RE: Blue Cross Animal Clinic
1656 University Blvd NE
Grading and Drainage Plan
Engineer's Stamp Date: 11/14/2021
Hydrology File: H15D015B

Based upon the information provided in your submittal received 11/23/2021, the Grading & Drainage Plan **is not** approved for Building Permit. Following comments need to be addressed for approval of the above referenced project:

SHEET C101

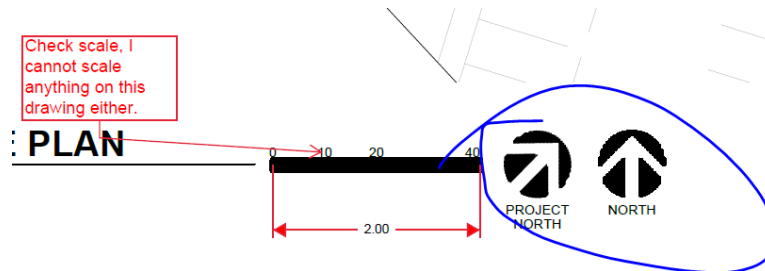
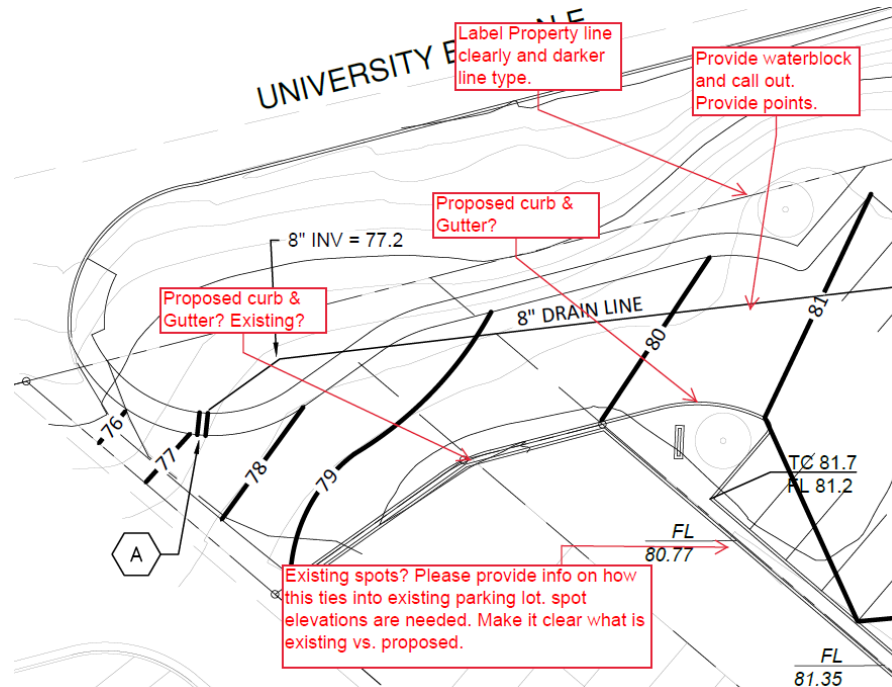
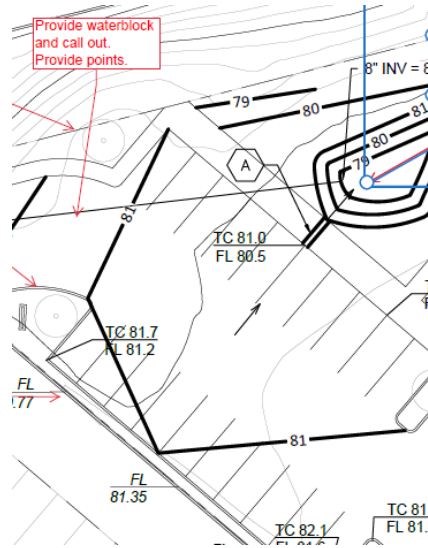
- a.
2. Please clearly show what is proposed vs. existing, label properties, include line types in the legend, and please provide existing spot elevations from survey.

3. Label all ponds and volumes and include sections with all water elevations for storms defined by the DPM.
4. Does this site fall under the classification to require the dumpster to drain into the sanitary system?
5. Please define where offsite flow is coming from? There is no property to the east just the North Diversion Channel.
6. Please label the channel and show it on the plans. Please also reference easements associated with the channel (AMAFCA and include recording info).
7. Ensure you are utilizing new DPM for design. I do not see where your numbers match anything from recent DPM.
8. Provide a water block per standard detail 2426 at entrance. The shown grades do not show how it works with adjacent grades and seems it may all be flowing out the drive. Please clean this up to clarify.

9. Show how each pond will discharge into University Blvd. Is there any containment of the pond? How is it going to be treated? Slopes etc...
10. Please add a note under Grading Notes. "Side slopes need to be stabilized with Native Grass Seed (per City Spec 1012) with Aggregate Mulch or equal (Must satisfy the "Final Stabilization criteria" CGP 2.2.14.b.)".
